# F11a

# A-5-LGB-22-0060 (City of Laguna Beach) June 14, 2024 EXHIBITS

Subject: Coastal Commission Appeal A-5-LGB-22-0060, City of Laguna Beach Anita Street Beach Access

Exhibit 5: Conceptual layout of ADA accessible parking within the Revocable Encroachment Permit area.

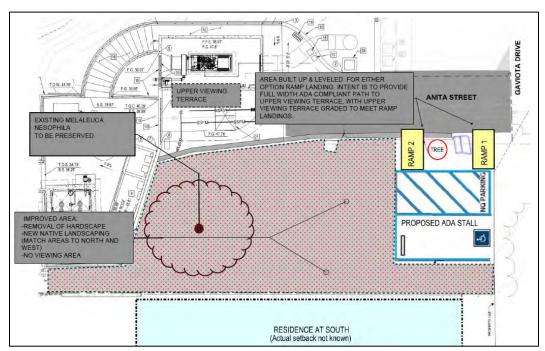
**Issue #3:** Review potential to add an ADA parking space at REP area or north of street end.

**Response:** CASp Experts LLC has reviewed the REP and determined that it is feasible to construct an ADA compliant parking space with a van loading zone within the REP as shown in Exhibit 5. A detailed analysis is included as Attachment 1. The ADA parking space would replace the design review approved public amenities such as the loading zone, bench seating, water station, bike racks, and surfboard racks. The approved design (Design Review 22-0120) shown in Exhibit 6 was reviewed and approved by the City of Laguna Beach Design Review Board (DRB) on April 28, 2022. Any significant change to the plan would require an additional review and approval from the DRB.

Exhibit 7: Stair analysis.

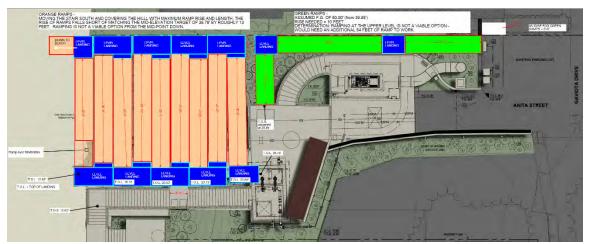
Issue #4: Analyze feasibility to provide a ramp, elevator, or funicular to provide ADA access to beach.

An ADA-compliant ramp must include a level landing every 30' of run and at each change in direction. In addition, the ramp cannot exceed a slope of 8.33%. CASp Experts LLC looked at eliminating stairs between the top landing and middle landing and between the middle landing and the beach. The areas are depicted in Exhibit 7.

Top Landing to Middle Landing – The grade difference between the top landing and the middle landing is 105 inches. This requires a ramp of 105' with at least four (4) level landings. The space will only accommodate a ramp length of approximately 66'.

Middle Landing to Beach Level – Based on the grade difference from the middle landing to the beach level, the ramp between the middle landing and beach level will require a ramp 378 feet long with thirteen (13) level landings. The space available for this ramp will only accommodate approximately 270 feet of ramp. This would leave the bottom of the ramp approximately nine feet (9') above the beach level.

Based on the discussion above, it is not feasible to eliminate stairs to construct an ADA compliant ramp from the top landing to the middle landing or to beach level because there is not enough space available within the right-of-way and because the existing and proposed sewer facilities create physical barriers and design constraints.
